# UNITED STATES PATENT AND TRADEMARK OFFICE

# Office Action Summary

10/017,924

HUANG ET AL.

Fig. 10

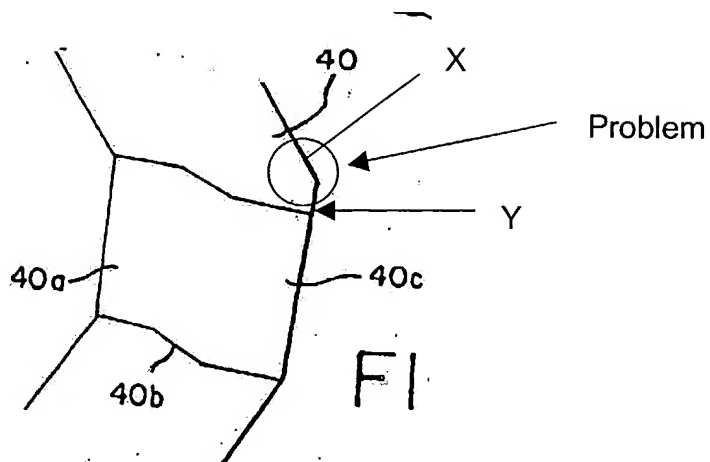
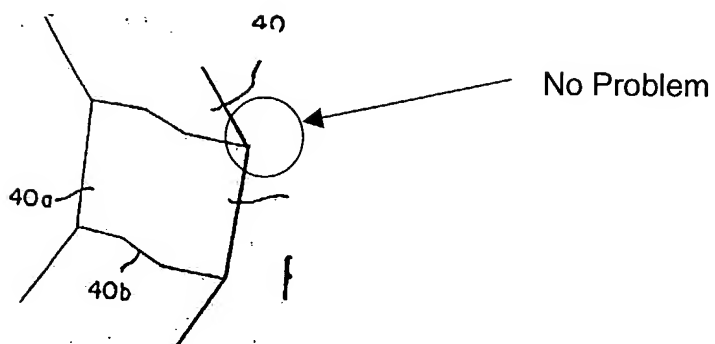
A drawing was received on 2/17/04. This drawing includes changes acceptable as the drawing overcomes the objections stated in the final office action. However, due to further review and understanding of the invention, Figure 10 has a discrepancy as follows.

The drawings are objected to because Figure 10 is out of proportion in respect to the line X, as shown in the attachment A provided herein, not joining at the intersection Y. The examiner has provided what Fig. 10 should be.

Fig. 10 should be

Fig. 7

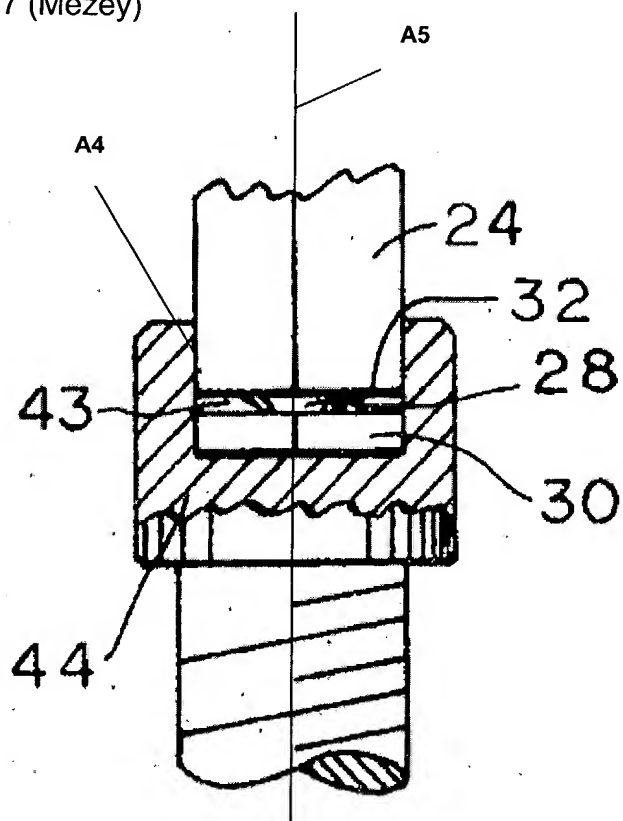
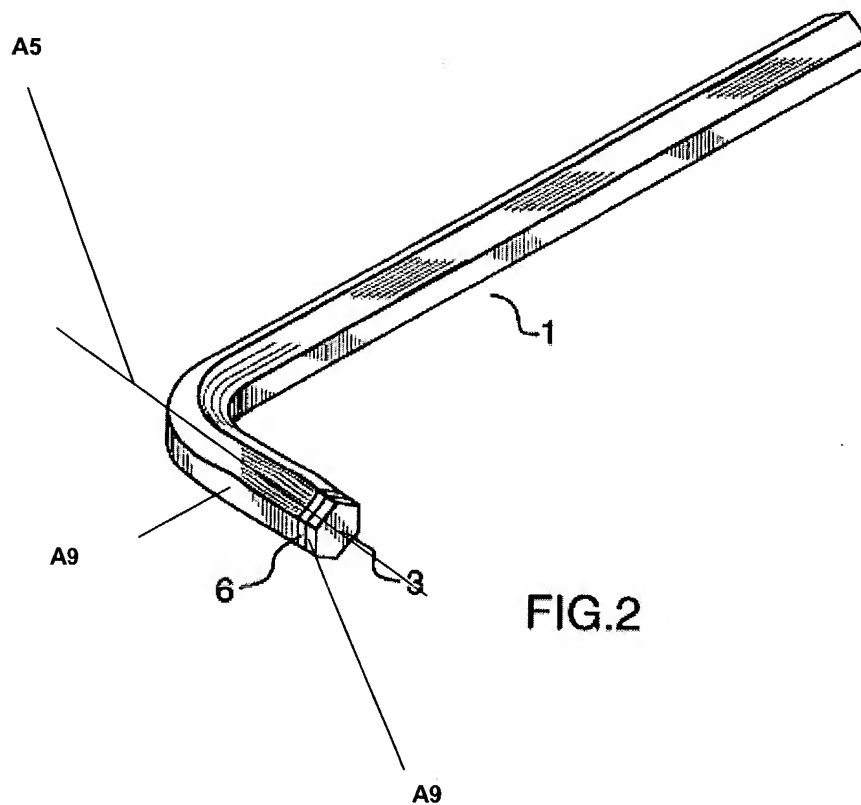
Regarding claim 1, Mezey discloses, in Figure 7, an interface between a driving member **24** and a driven member **44**. The driving member **24** has a polygonal length **38** having at least one surface selected from a group consisting concave and convex surfaces. The driven member **44** has a matching polygonal length **A4**. The polygonal length **38** or the matching polygonal length **A4** includes a twisted portion **30** twisted along an axis **A5** of the polygonal length **38** or the matching polygonal length **A4**.

However, Mezey fails to disclose the polygonal length **38** having at least one surface selected from a group consisting concave and convex; and, the twisted portion **30** being twisted from 10' to one degree. Mezey suggests that other configurations of the interface can be made (col. 3, line 50 to col. 4, line 2). Therefore, one applying the invention to Torx heads or sockets will find that the polygonal length will include a concave polygonal length. Furthermore, it would have been obvious matter of design consideration to make the twist at different degrees as being dependent on the gap between the driving member and the driven member. Mezey is concerned with slippage thus a small gap between the untwisted part in the interference will require a lesser amount of twist to prevent slippage as a result of the torque the twisted portion applies to the matching polygonal length. Therefore, as taught by Mezey, it would have been obvious to one of ordinary skill in the art at the time the invention was made to make the twist twisted from 10' to 1 degree to prevent slippage at lesser gaps between the untwisted portion of the driving member and the driven member.
